MIL-R-85895 (AS) 28 MARCH 1988

RACK, BOMB EJECTOR, AIRCRAFT BRU-32/A

INCH-POUND MIL-R-85895(AS) AMENDMENT 1 18 March 1991

This amendment forms a part of MIL-R-85895(AS), dated 28 March 1988, and is approved for use by the Naval Air Systems Command, Department of the Navy, and is available for use by all Departments and Agencies of the Department of Defense.

TABLE V - Static Test Limit Loads

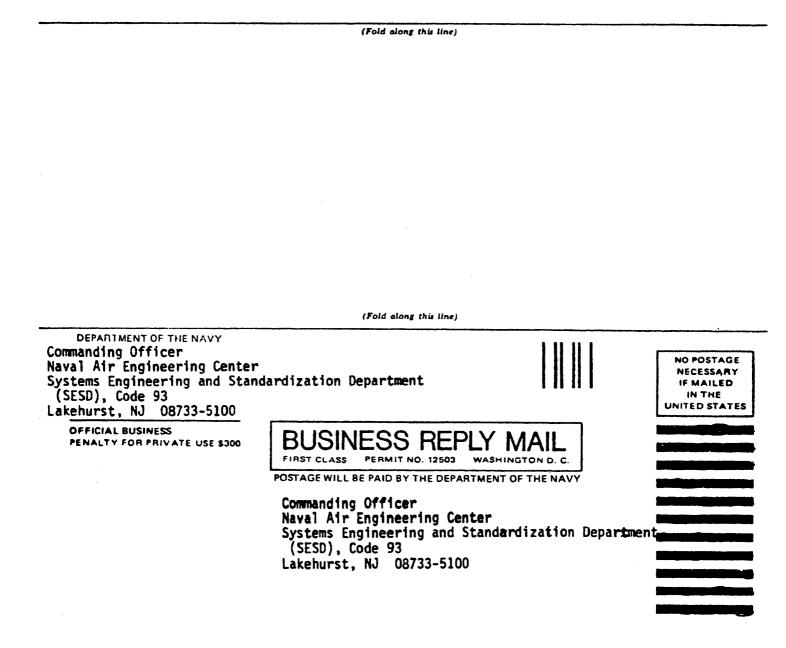
Delete existing table V in its entirety and substitute table V as shown

"TABLE V. Static test limit loads.

Simulated store characteristics

Store	Lug cent		Longitudinal dimension aft of lug <u>1</u> /			dimensi of stor	
A B C	30 inch 30 inch 30 inch		15.0 inch 15.0 inch 11.93 inch			.0 inct .125 inct .35 inct	ן ו
Combined	l limit lo	ads and mor	nents abou	ut referend	ce points ((store c	.g.) <u>2</u> /
Conditic	on Store	Pz vert- ical	Py side	Px longi- tudinal	Mzz yaw moment	Myy pitch moment	Mxx roll moment
1 2 3	A B C	-15,400 -13,818 -13,380	11,533 11,515 11,500	1,833 -13,818 -20,700	4,400 -21,081 -29,052	38,133 76,350 121,050	
Sign convention							
+Px = Longitudinal aft +Py = Side to port +Pz = Vertical up +Z = Vertical up +Pz = Vertical up +Pz = Vertical up +Pz = Yaw nose to port

$\underline{1/}$ The centrold of the loads shall act at a point In accordance with these dimensions.

$\underline{\it 2/}$ All loads are in pounds. All moments are In inch-pounds."
